**ADDENDUM No. 1**

Date: January 27, 2015

Project Name: 3<sup>rd</sup> Street Reconstruction Phase 4 – Guadalupe St. to Nueces St.

C.I.P. No.: 8158.004

STORM DRAIN PLAN & PROFILE  
 WEST 3RD STREET AT SAN ANTONIO STREET SHEET 1

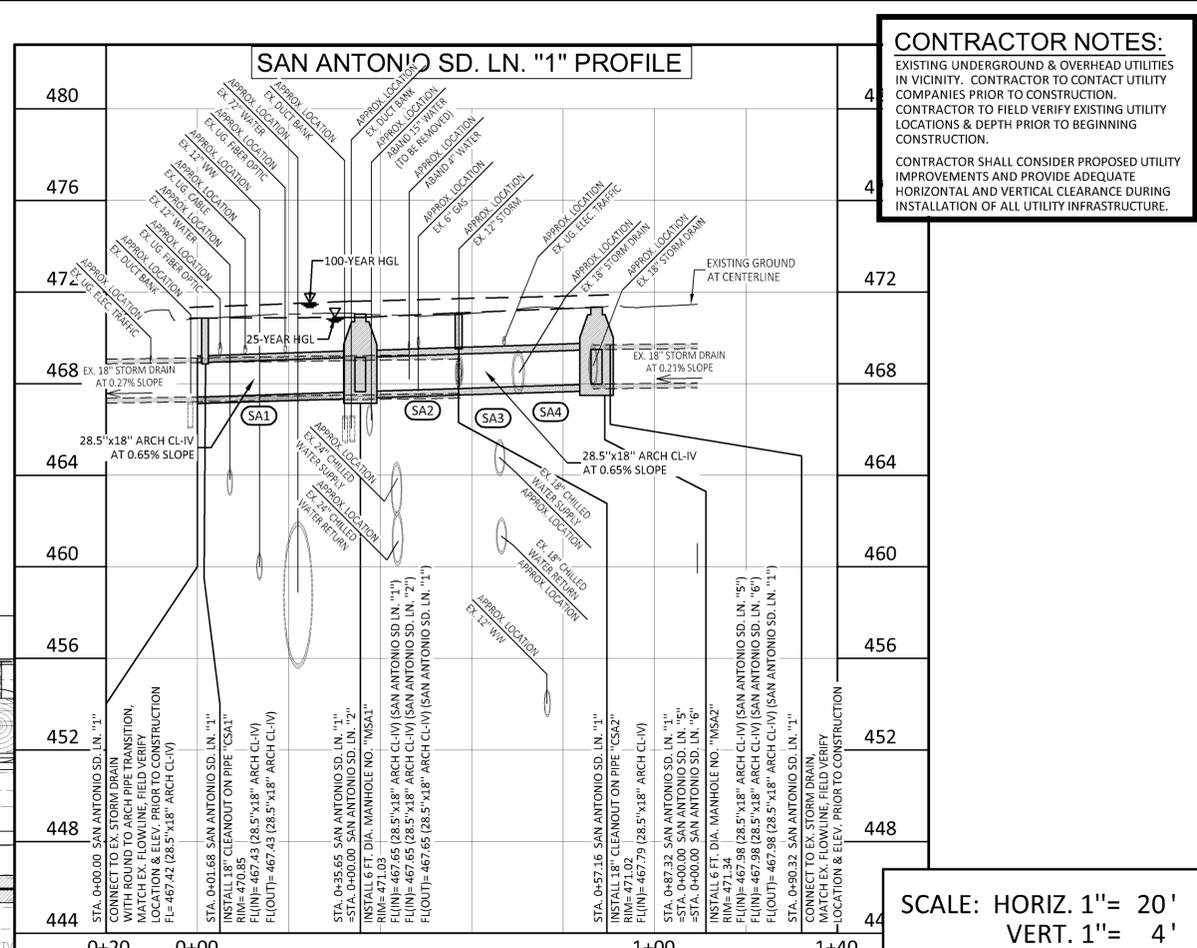
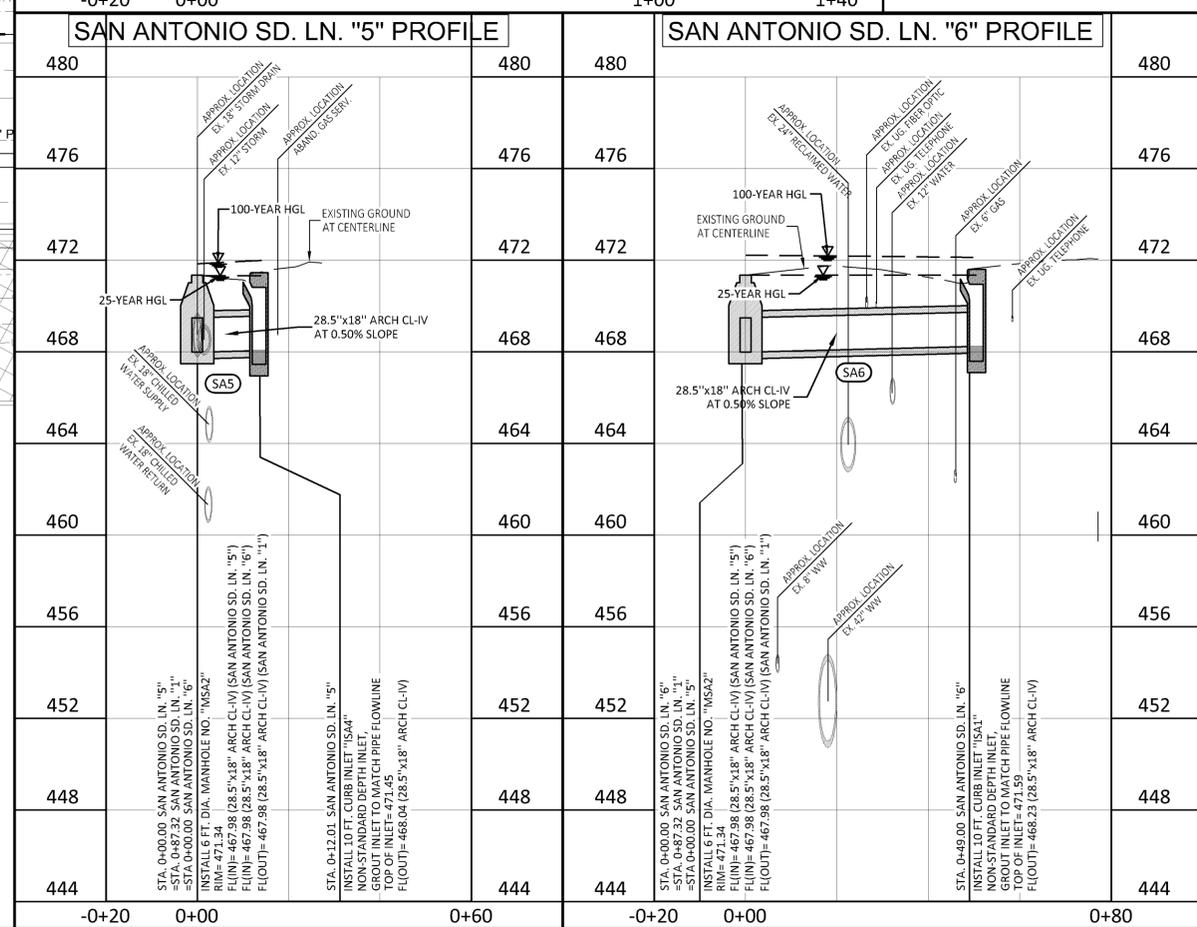
REMOVE EXISTING ABANDONED WATER LINE.

ADJUST STORM DRAIN LINE "2" ALIGNMENT TO AVOID CONFLICT WITH EXISTING UE DUCT.

REV. NO.	DATE	REVISION DESCRIPTION
1	JRK 1/27/2015	ADD 1 - ADDRESS

CITY OF AUSTIN, TEXAS  
DEPARTMENT OF PUBLIC WORKS  
ENGINEERING SERVICES DIVISION  
3RD ST. RECONSTRUCTION  
PHASE 4 - GUADALUPE ST. TO NUECES ST.  
STORM DRAIN PLAN & PROFILE  
WEST 4TH STREET AT NUECES STREET SHEET 2

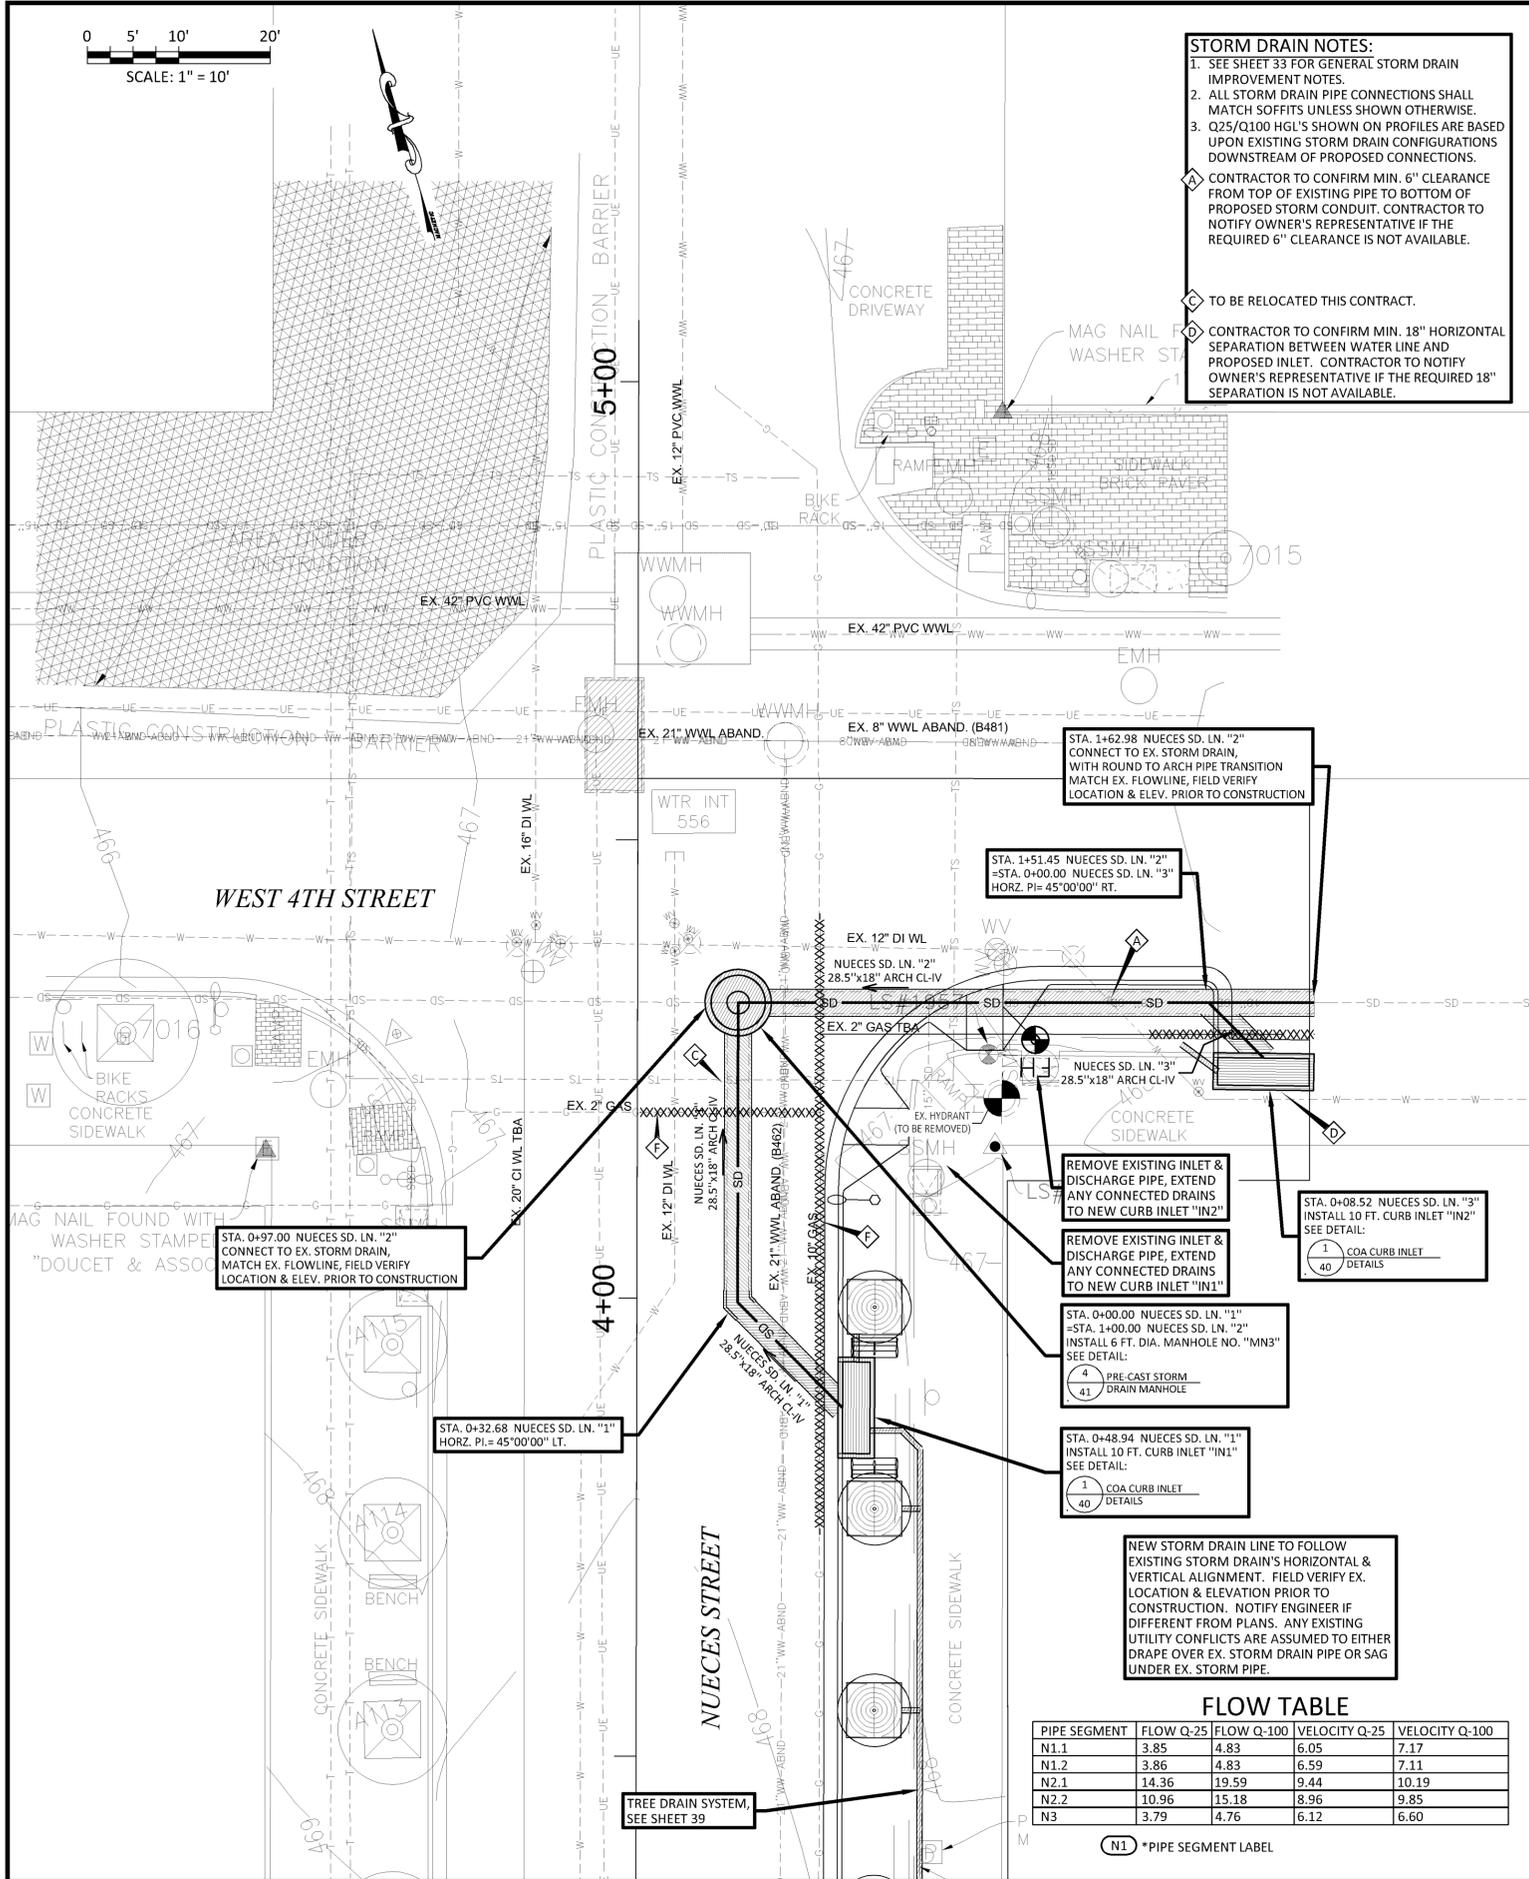
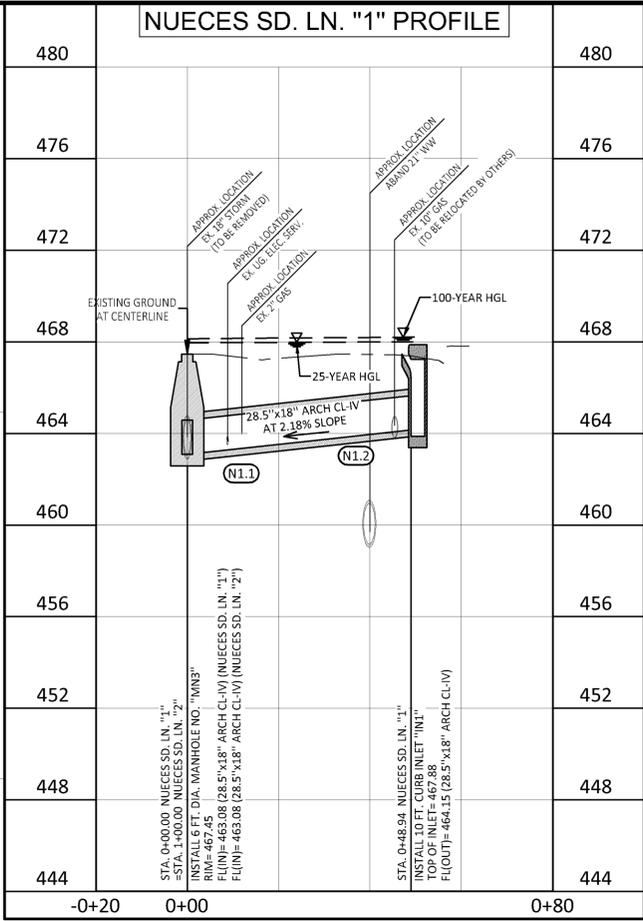
CONTRACTOR TO CONFIRM MIN. 18" HORIZONTAL SEPARATION BETWEEN WATER LINE AND PROPOSED INLET. CONTRACTOR TO NOTIFY OWNER'S REPRESENTATIVE IF THE REQUIRED 18" SEPARATION IS NOT AVAILABLE.

REV. NO.	BY	DATE	REVISION DESCRIPTION
1	JRK	1/27/2015	ADD 1 - ADD NOTE

CITY OF AUSTIN, TEXAS  
 DEPARTMENT OF PUBLIC WORKS  
 ENGINEERING SERVICES DIVISION  
 3RD ST. RECONSTRUCTION  
 PHASE 4 - GUADALUPE ST. TO NUECES ST.  
 NUECES : WATERLINE W1  
 STA. 0+00 - 0+56.67

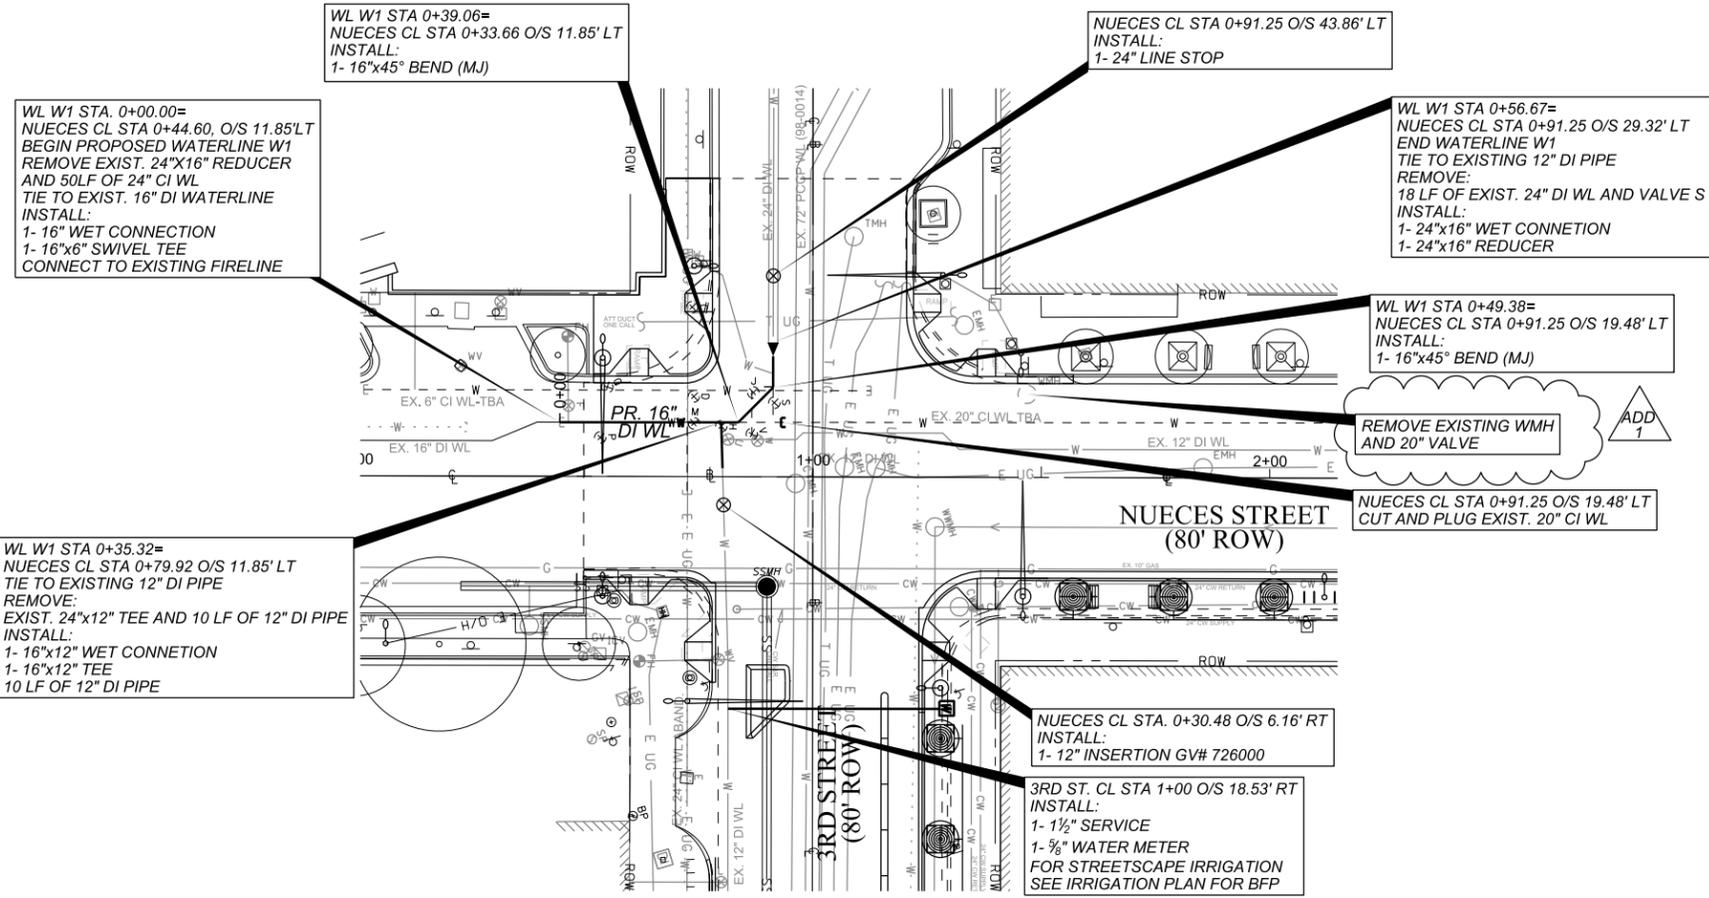
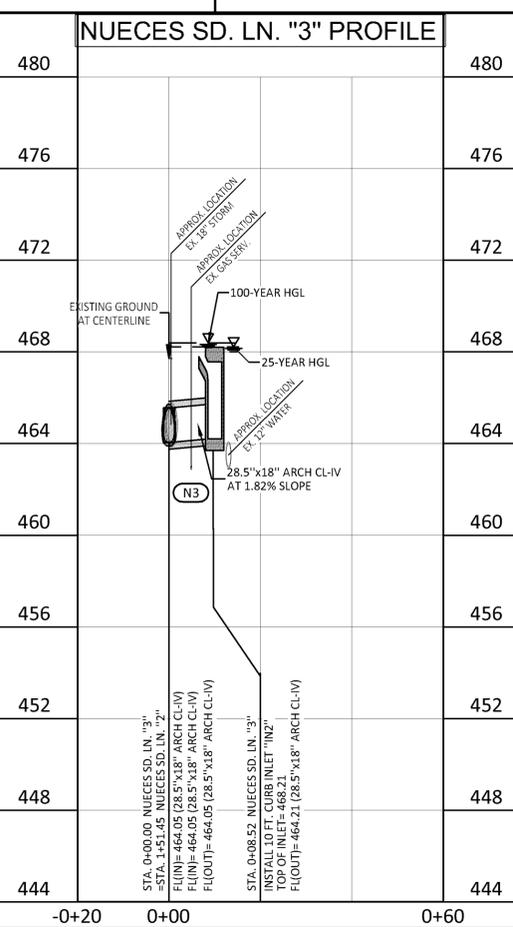
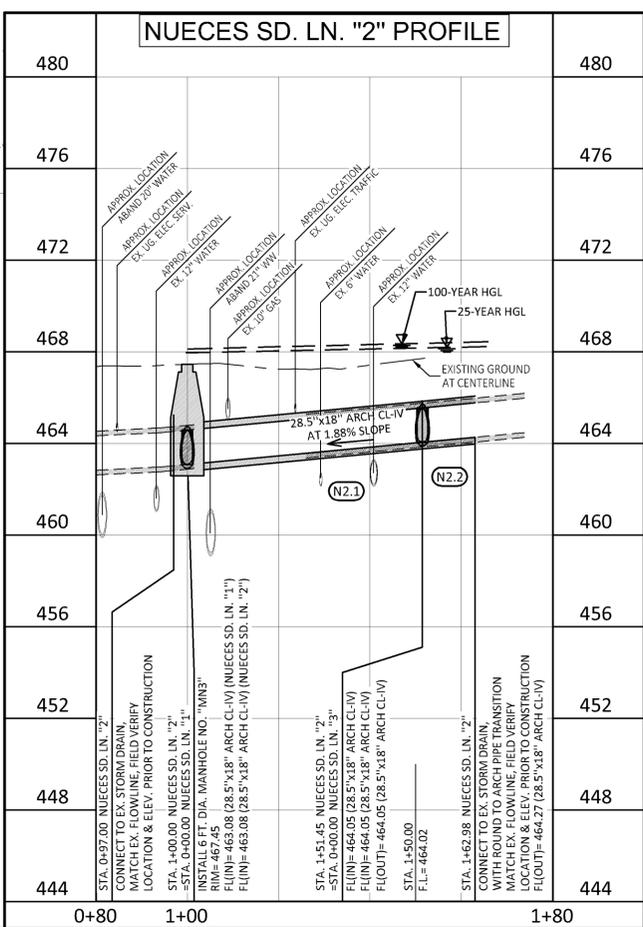
REV. NO.	DATE	REVISION DESCRIPTION
ADD FR	01/27/15	ADDENDUM T-CALLOUT UPDATED
